**ZONING BOARD OF APPEALS APPLICATION FOR PUBLIC HEARING (VARIANCES, SPECIAL EXCEPTIONS, APPEALS OF ADMINISTRATIVE DECISIONS)**

Address: 828 S Stone Mountain Lithonia Rd City: Lithonia State: GA Zip: 30088

# Plan Review - Workflow Routing Slip

# Plan Review - Review Details

STRUCTURAL  
DRAWINGS &  
MISC DETAILS  
A6

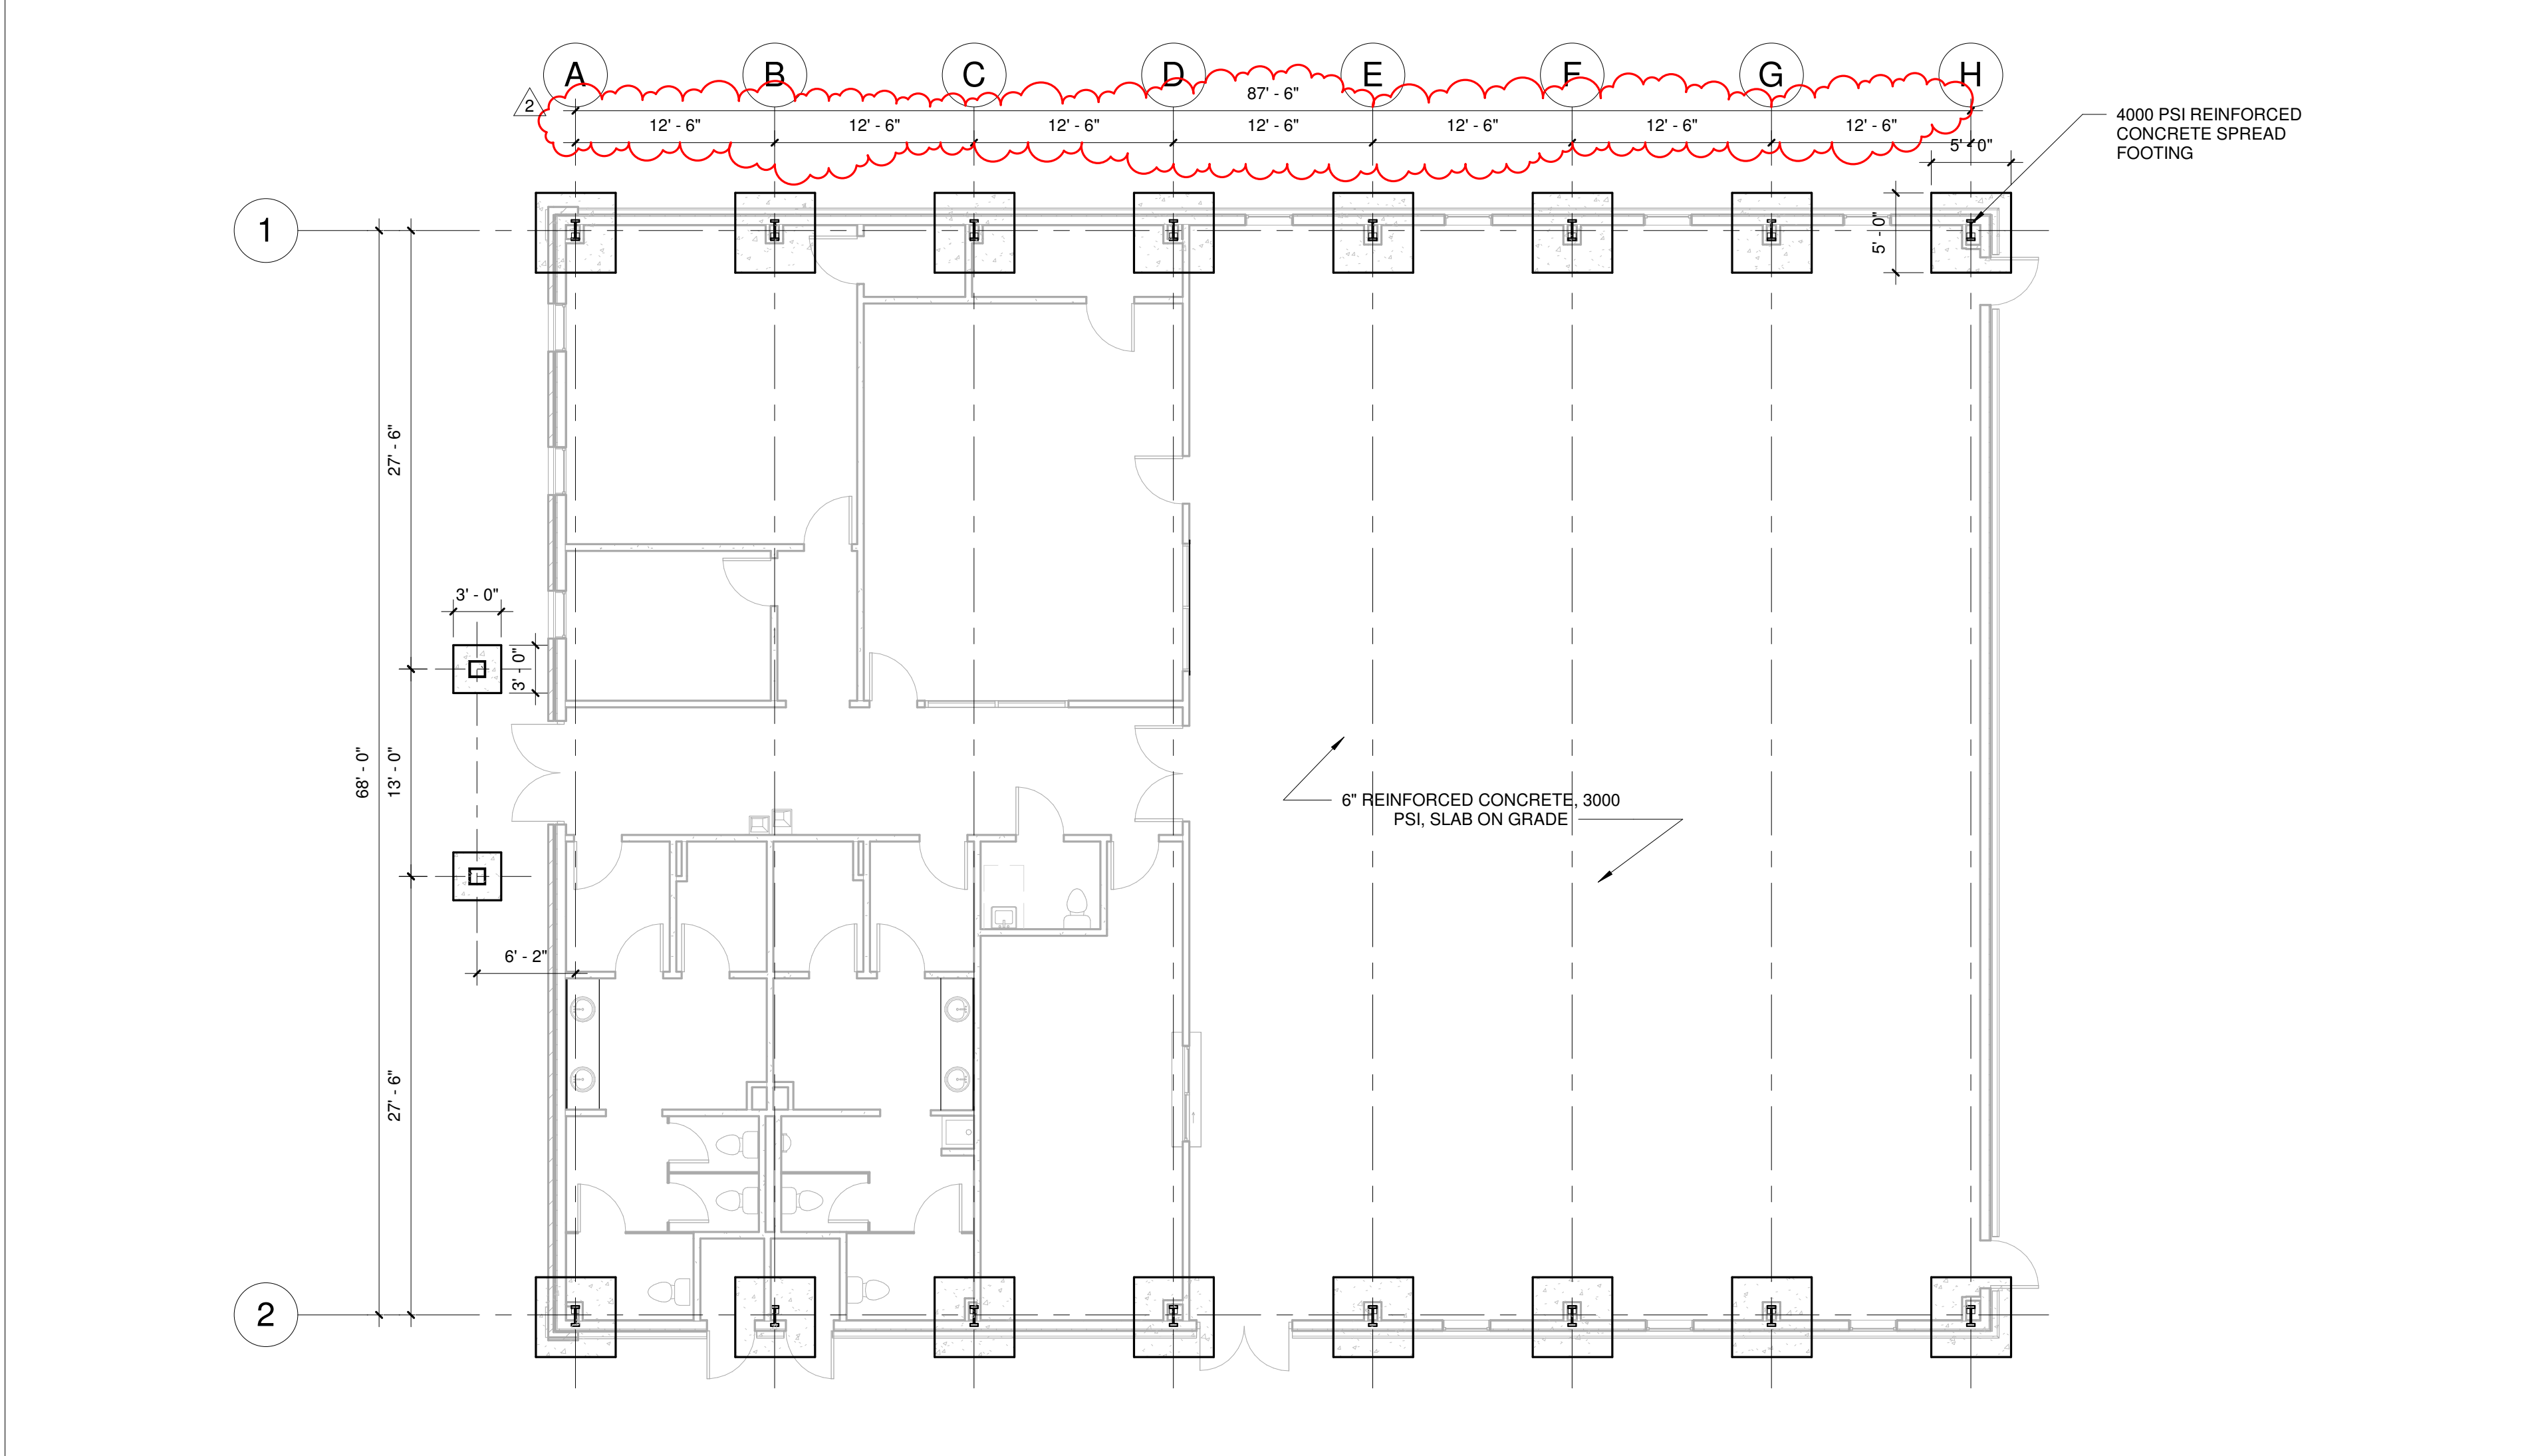
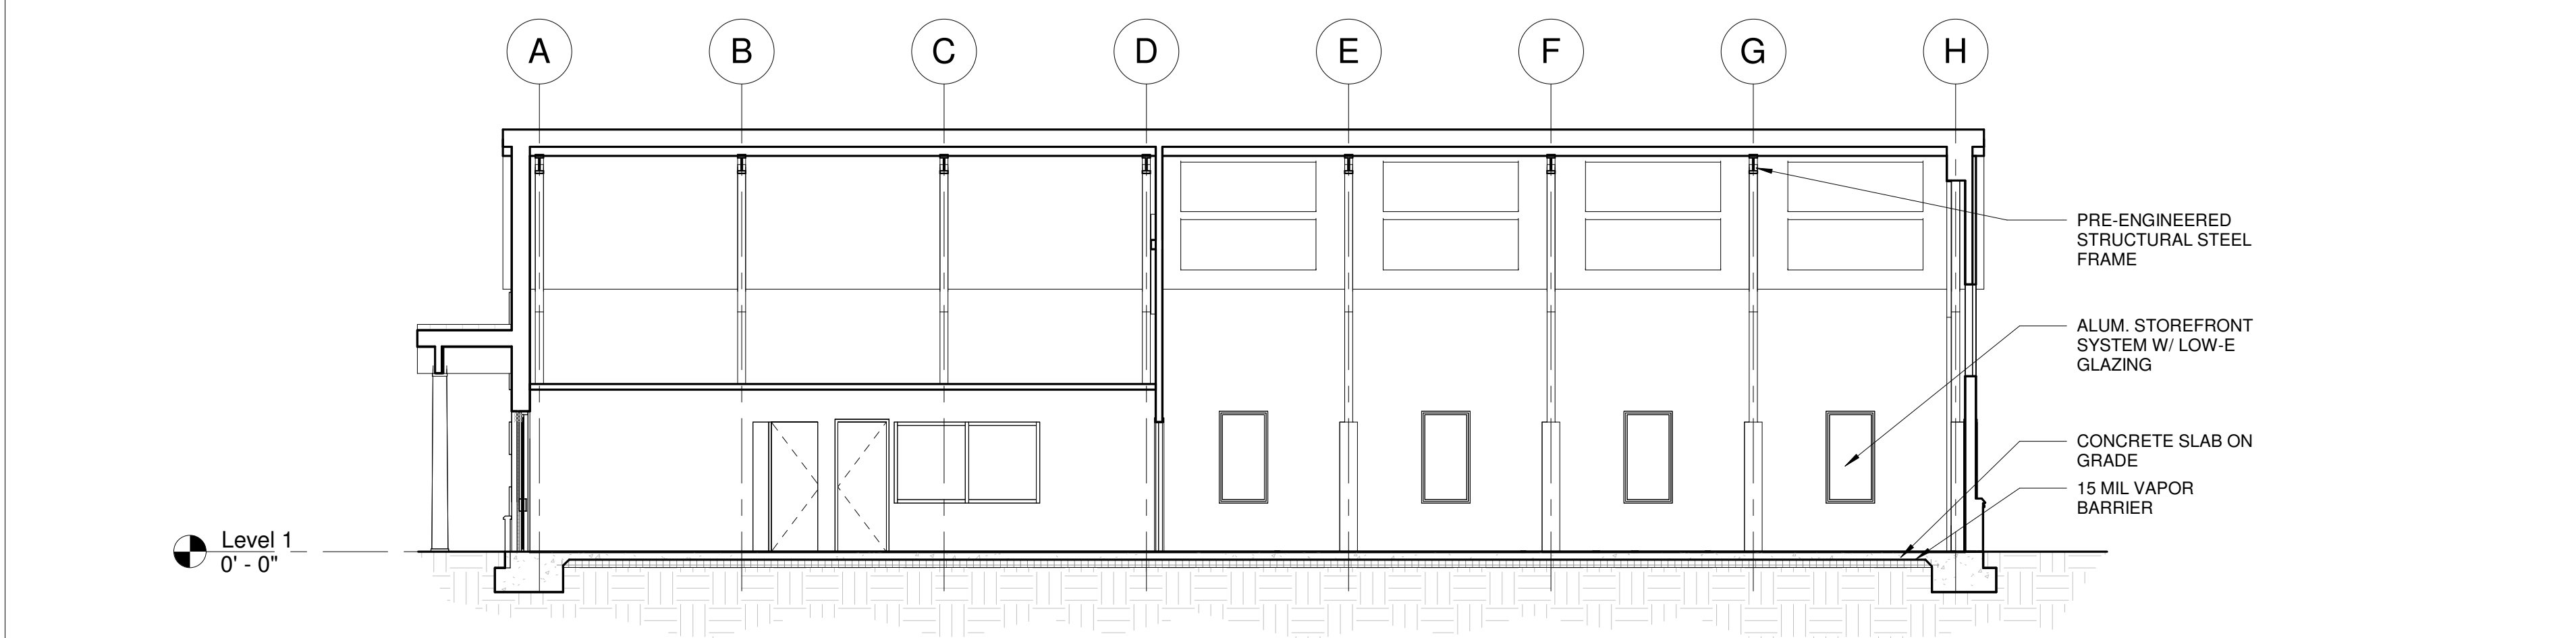
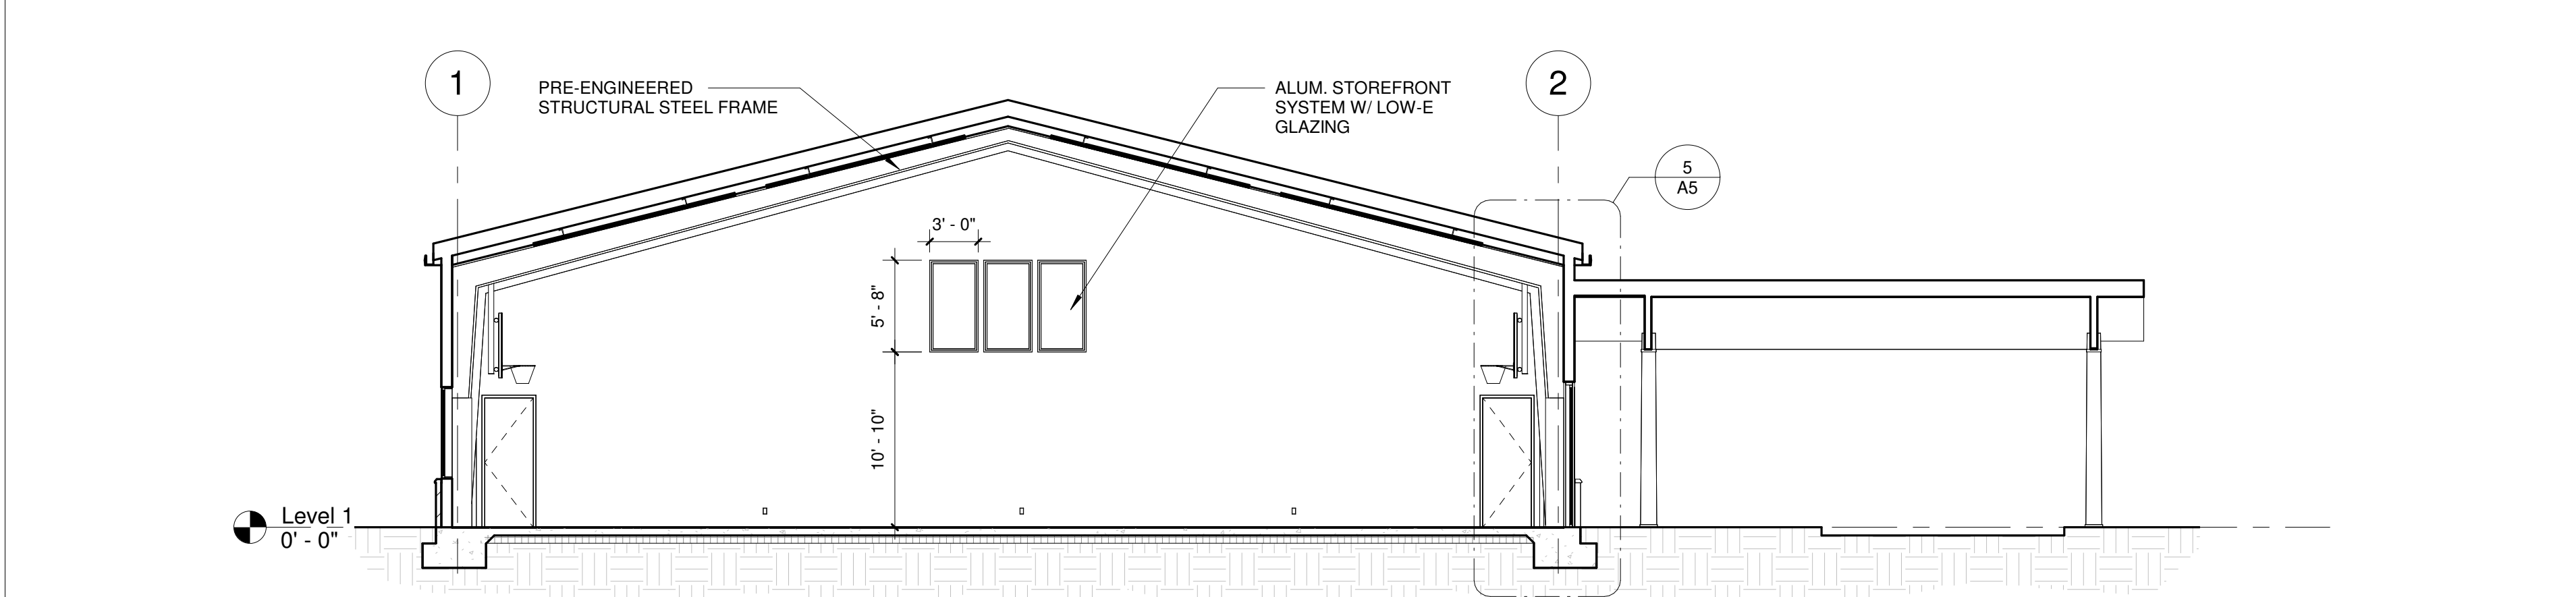
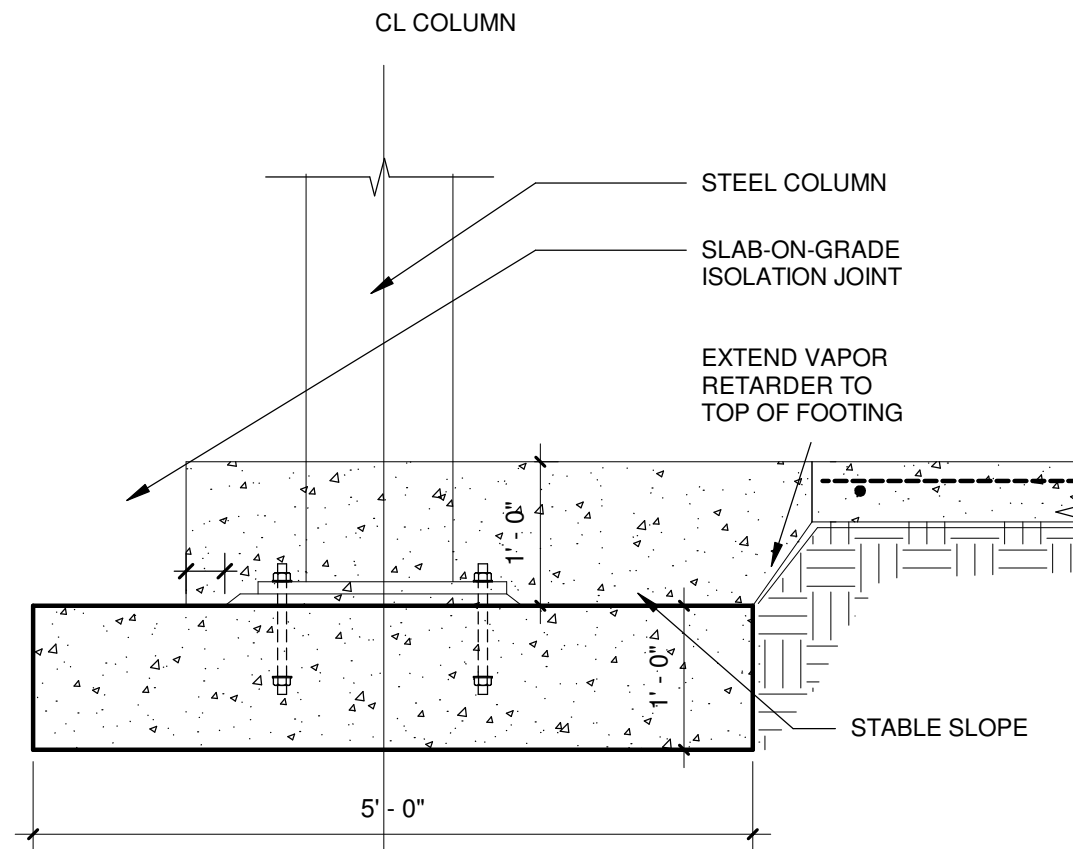
19	1	COMMERCIAL STRUCTURAL PLANS Tony Pruitt 11/15/23 12:03 PM	Changemark RISK CATEGORY PLEASE REVIEW 2018 IBC 1604.5 SECTION AND SHOW COMPLIANCE FOR THE PROPOSED ASSEMBLY STRUCTURE WITH AN OCCUPANT LOAD OF 522.	A6 Structural Drawings and Misc Details.pdf	Responded by: Christopher TzegaegbE - 6/25/24 10:59 AM Revision submitted  ----- Responded by: Christopher TzegaegbE - 4/16/24 11:15 AM Revision made on latest submitted version V3  ----- Responded by: Christopher TzegaegbE - 3/13/24 8:58 AM Revisions made	Info Only
